PARTIAL LEVEL-09 FRAMING PLAN (PHASE-8) (SEQ#47)

SK#23
17 pages
35 Queries
Date: 07-14-2025

PROJECT DESCRIPTION : 1250 MARYLAND AVENUE

PARTIAL LEVEL-09 FRAMING PLAN (PHASE-8) (SEQ#47)

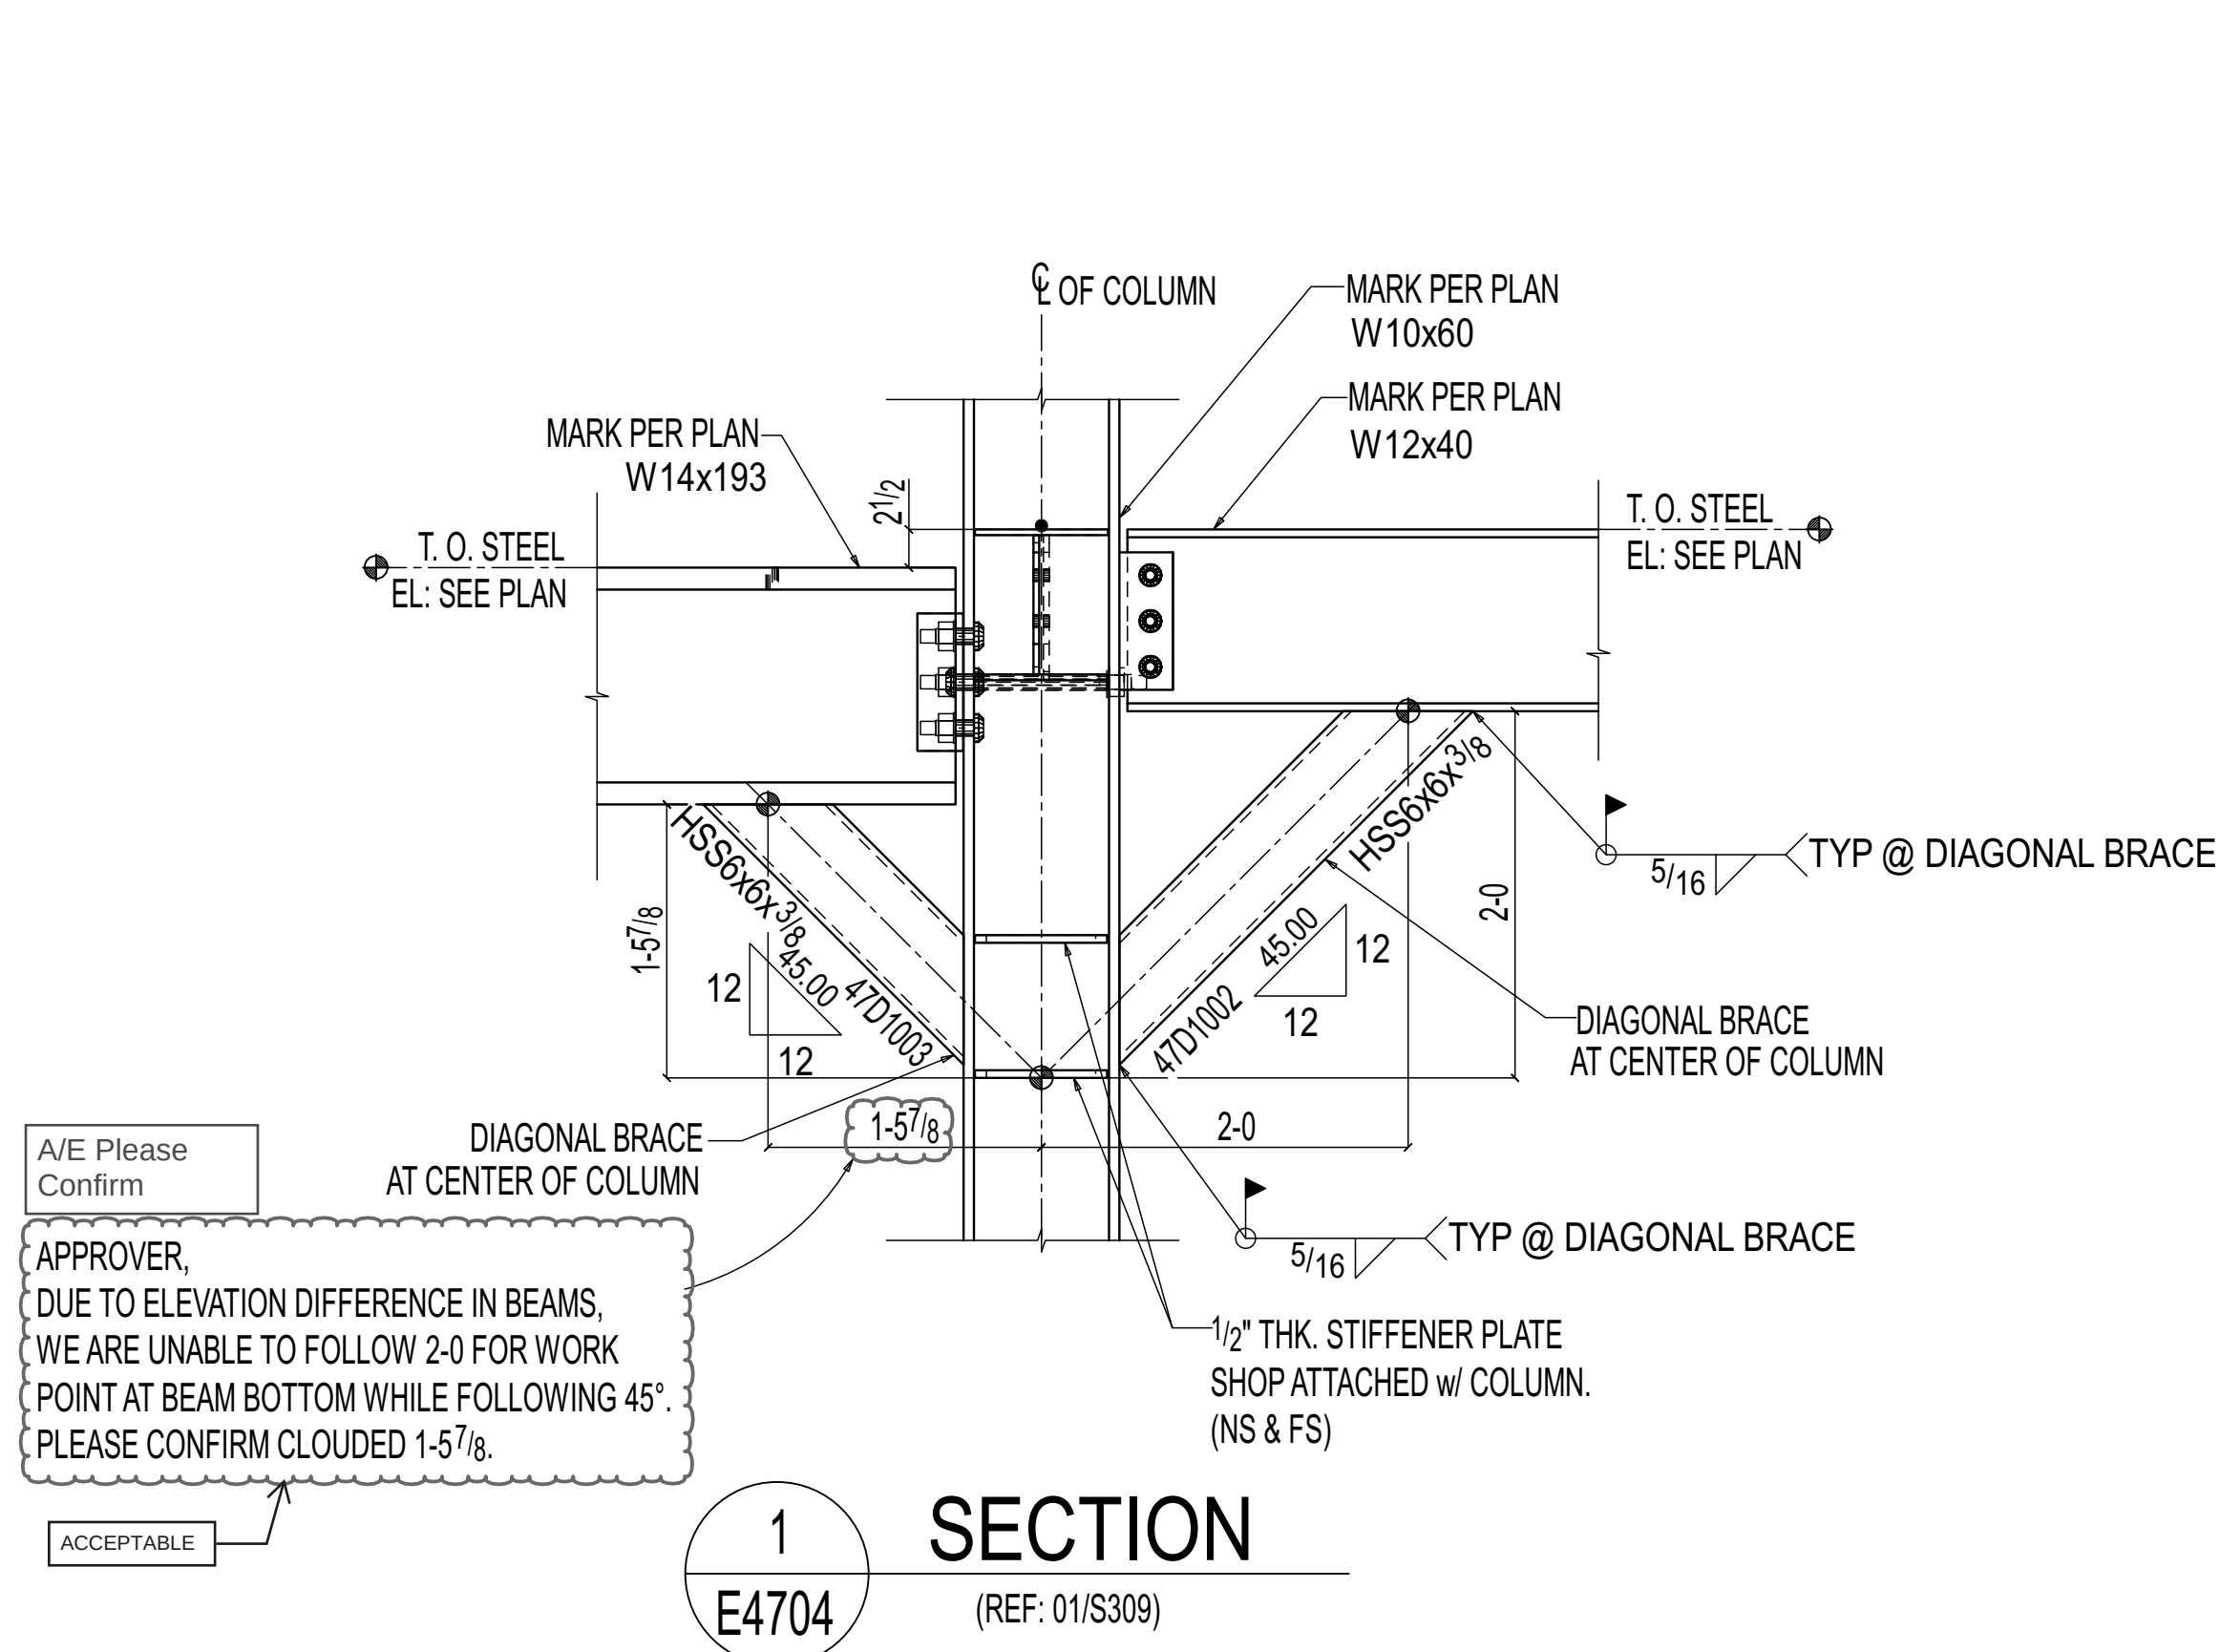
Q20
Please review the yellow clouded note and advise.

Q21
Please confirm the orange clouded beam location is OK to proceed?

Q22
We purposely used (2)W10x12 beams to avoid elevations differences at magenta clouded beam which supports the stair. We can't maintain same dimensions for Treads & risers if we lower the magenta clouded beam for the joists.

Please review & confirm, shall use the green highlighted W10x12 beams in lieu of joist.

LEVEL-10 FRAMING PLAN (PHASE-8)-(SEQ#48)

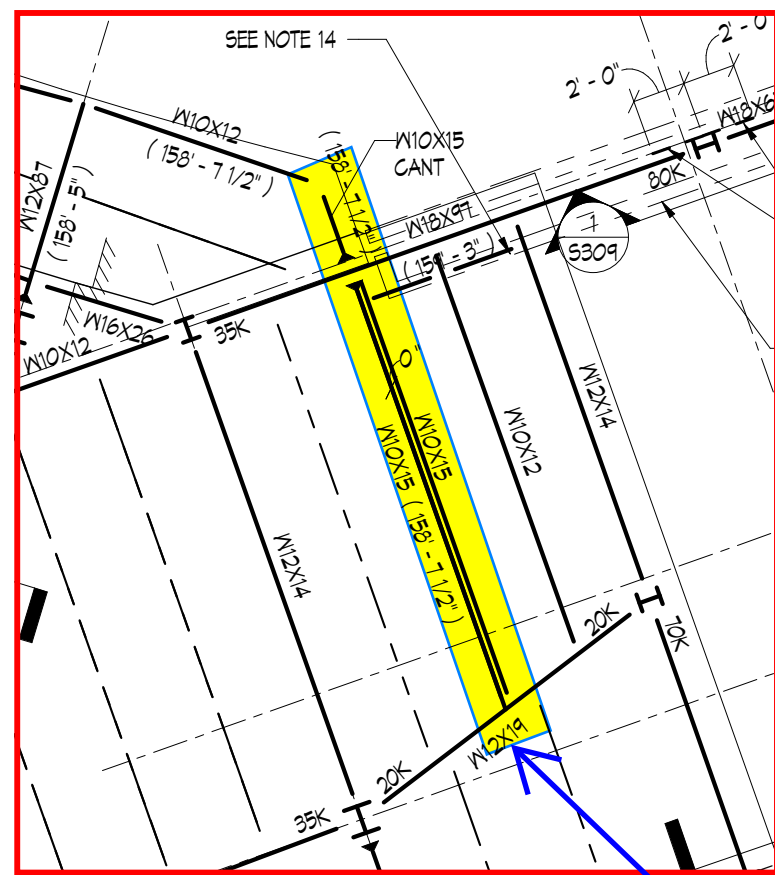
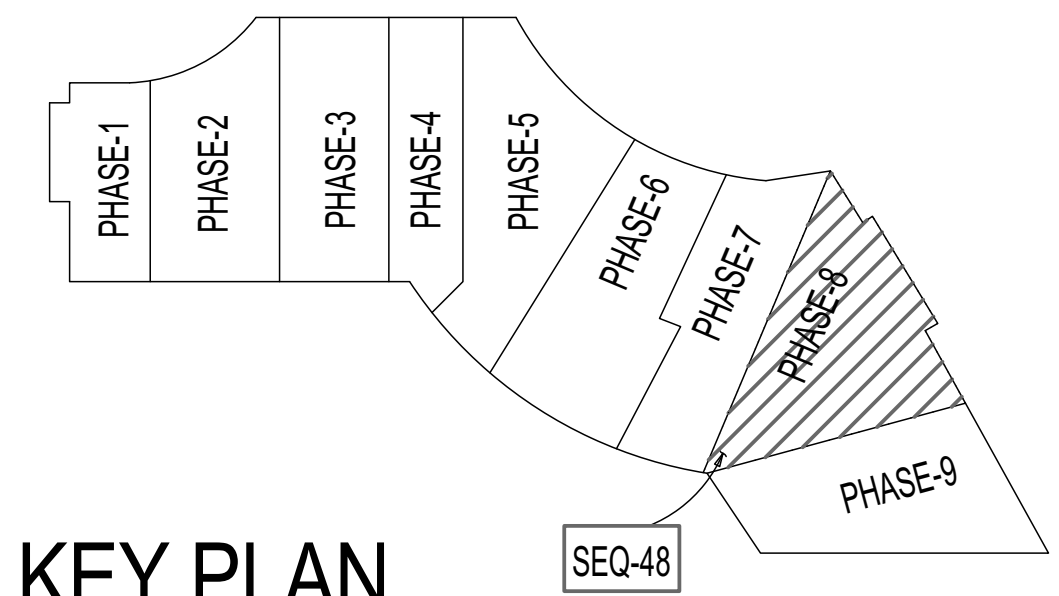
We have followed the edge of slab dimension 0'-3" from grid 31 per latest architectural drawing 2/A057 in lieu of 8" marked by Arch. Please confirm.

We assumed green clouded dimension should be 6-9 as it is. If the yellow clouded cantilever beam also need to moved to match the 6-6 which supersedes the condition that all beam center along edge of slab should be located 1-0 from edge of slab.

Please review & confirm shall we use 6-9"?

1. APPROVER, DUE TO CONNECTION ARRANGEMENT AND TO PROVIDE ERECTION FEASIBILITY, WE HAVE ADJUSTED THE BEAM WORK POINT OFFSET FROM COLUMN CENTER. PLEASE CONFIRM IF IT IS ACCEPTABLE.

2. APPROVER, PLEASE CONFIRM ALL JOIST SPACINGS ARE OK TO PROCEED?
3. APPROVER, PLEASE CONFIRM ALL CLOUDED BEAM LOCATIONS ARE OK TO PROCEED?
4. APPROVER, PLEASE CONFIRM THE CLOUDED COLUMN LOCATIONS ARE OK TO PROCEED?

5. APPROVER, PLEASE CONFIRM THE CLOUDED BEAM SECTION SIZE IS OK TO PROCEED?
6. APPROVER, PLEASE CONFIRM THE CLOUDED BEAM ELEVATION IS OK TO PROCEED?
7. APPROVER, PLEASE CONFIRM THE CLOUDED BEAM END DIMENSION IS OK TO PROCEED?

8. APPROVER, PLEASE CONFIRM THE CLOUDED BEAM LOCATION WE HAVE CHANGED THIS BEAM LOCATION FROM CENTER OF COLUMN TO MATCH STAIR CO-ORDINATION DRAWINGS.
9. APPROVER, PLEASE CONFIRM THE CLOUDED BEAM LOCATION WE HAVE CHANGED THIS BEAM LOCATION FROM CENTER OF COLUMN TO MATCH STAIR CO-ORDINATION DRAWINGS.

10. APPROVER, PLEASE CONFIRM THE CLOUDED BEAM LOCATION WE HAVE CHANGED THIS BEAM LOCATION FROM CENTER OF COLUMN TO MATCH STAIR CO-ORDINATION DRAWINGS.
11. APPROVER, PLEASE CONFIRM THE CLOUDED BEAM LOCATION WE HAVE CHANGED THIS BEAM LOCATION FROM CENTER OF COLUMN TO MATCH STAIR CO-ORDINATION DRAWINGS.

Please confirm the magenta clouded beam's section size are OK to proceed?

1
E4802
DETAIL
OTHERS NOT SHOWN FOR CLARITY

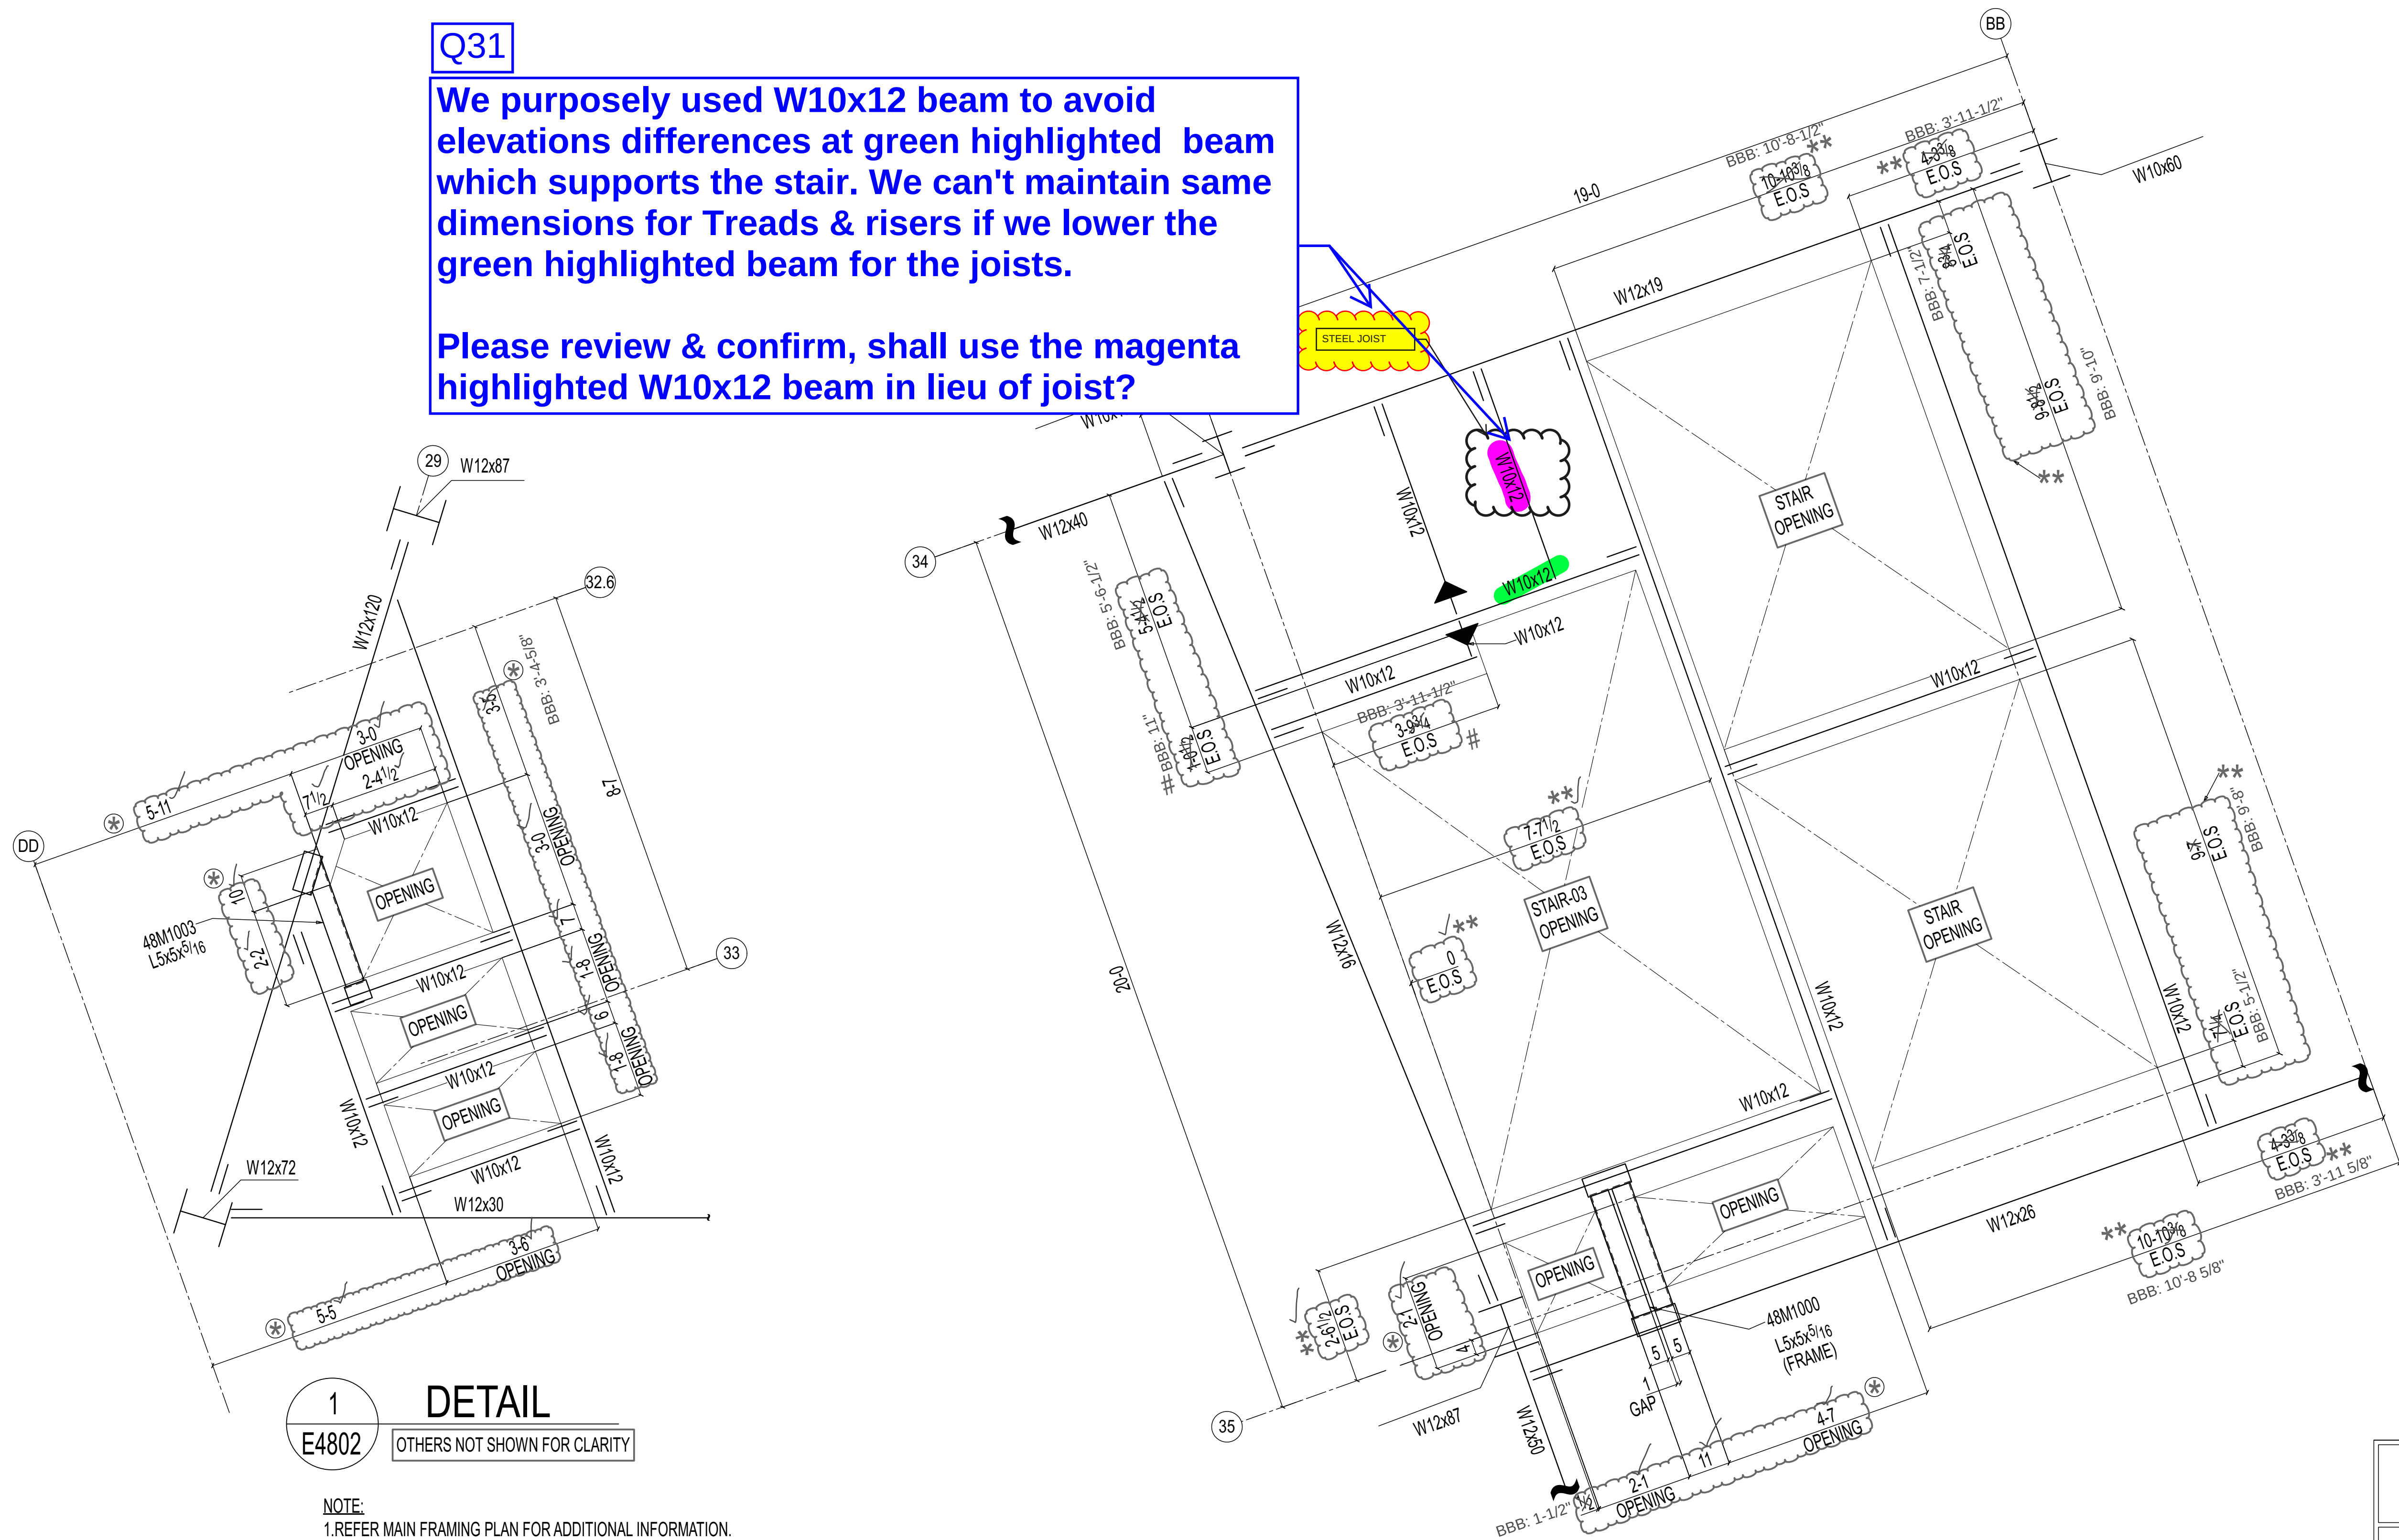
We purposely used W10x12 beam to avoid elevations differences at green highlighted beam which supports the stair. We can't maintain same dimensions for Treads & risers if we lower the green highlighted beam for the joists.

Please review & confirm, shall use the magenta highlighted W10x12 beam in lieu of joist?

**APPROVER, PLEASE CONFIRM THE CLOUDED EDGE OF SLAB DIMENSION FOR STAIR OPENINGS ARE OK TO PROCEED?

⊕APPROVER, PLEASE CONFIRM THE CLOUDED OPENING LOCATIONS AND OPENING SIZES ARE OK TO PROCEED?

NOTE
EDGE OF SLAB DIMENSIONS NEEDS TO BE CO-ORDINATED WITH STAIR DRAWINGS.

COORD. WITH ARCH. DRAWINGS AND MEP DRAWINGS FOR OPENING LOCATIONS
